## Art Commission Review – Submittal Form

**Project Name:** 59th Street Bridge over Amtrak Replacement

RE: City of Philadelphia Streets Department – 59<sup>th</sup> Street Bridge over Amtrak Replacement Project

On November 14, 2025, the Commission issued a decision of CONCEPT APPROVAL. Commission requested additional details/feedback from GFT and the City on the following items:

# Safety Concerns Between Roadway and Sidewalk

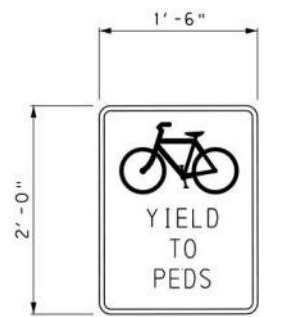
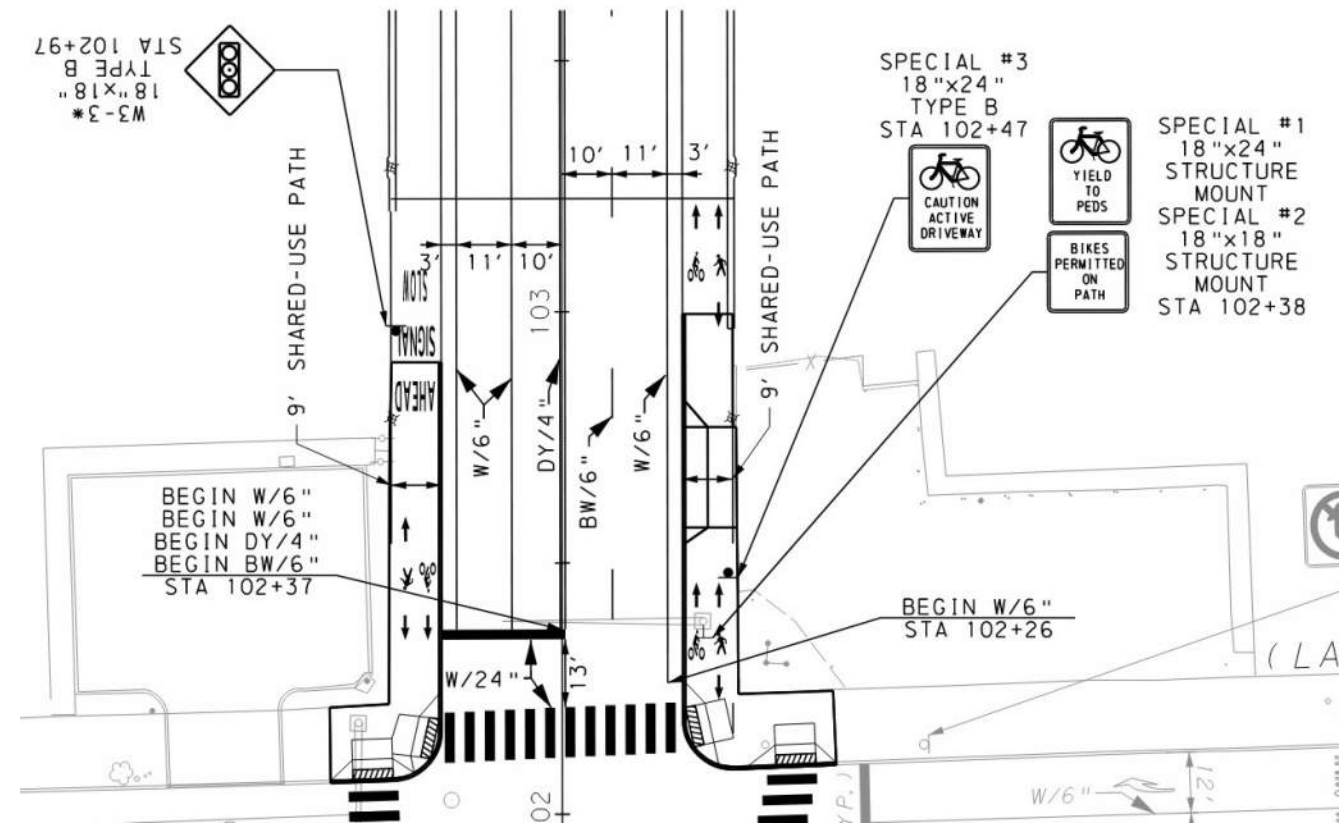
**Remarks:** The Commissioners requested added details about graffiti deterrence, wall materiality, the stability and durability of the acrylic panels, pedestrian lighting (including a plan view of all proposed and existing ambient light fixtures), future artwork process, and the community engagement process. The Commissioners also expressed safety concerns about the transition between the roadway and sidewalk, suggesting further exploration of design moves (paint, materiality, or barrier) that could more clearly and safely delineate the vehicular lanes from the sidewalk.

The Signing and Pavement Marking Plan for this project has been attached to this letter.

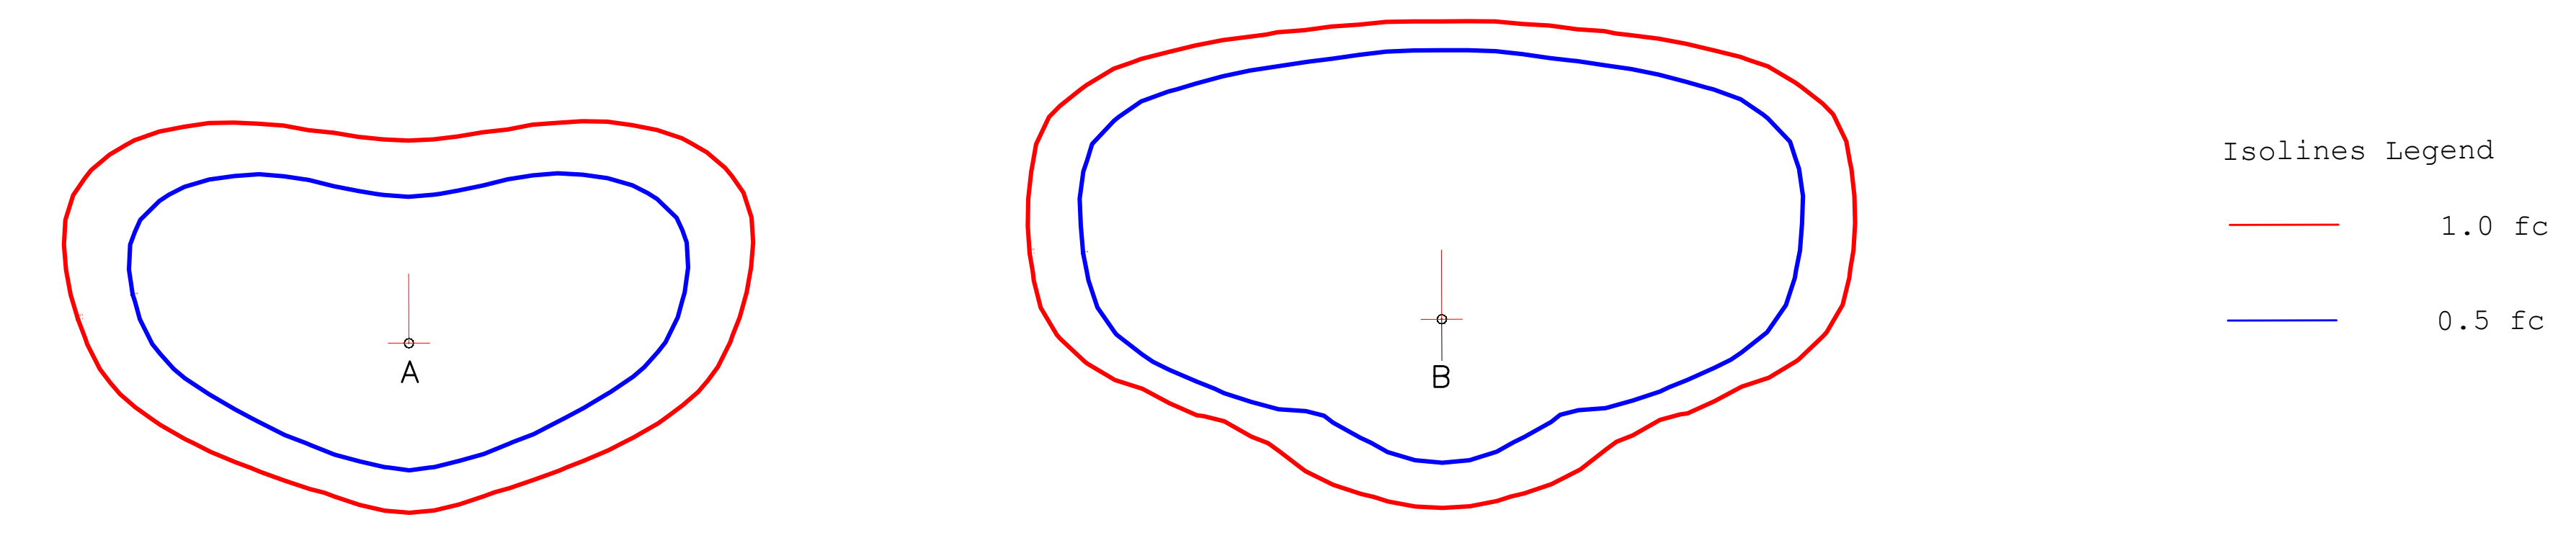
One of the improvements that is to be made as part of this project, based on coordination with local residence and City Councilmember Curtis Jones, Jr., is to enhance pedestrian lighting along the 59<sup>th</sup> Street corridor between Lancaster Avenue and Upland Way. It has been requested that lighting for pedestrian and vehicular traffic meet a minimum lighting intensity of 2 foot-candle. To meet this requirement, a lighting study/analysis was performed to show this requirement is met. Results of the lighting calculations and corresponding lighting isoline diagram are attached to this letter.

Isolines Legend  
 — 1.0 fc  
 — 0.5 fc

Horizontal Illuminance					
Label	CalcType	Units	Avg	Avg/Min	
SPA 102+00 to 113+21.37	Illuminance	Fc	3.23	1:19	
NW Sidewalk	Illuminance	Fc	3.68	3:48	
SW Sidewalk	Illuminance	Fc	3.23	4:31
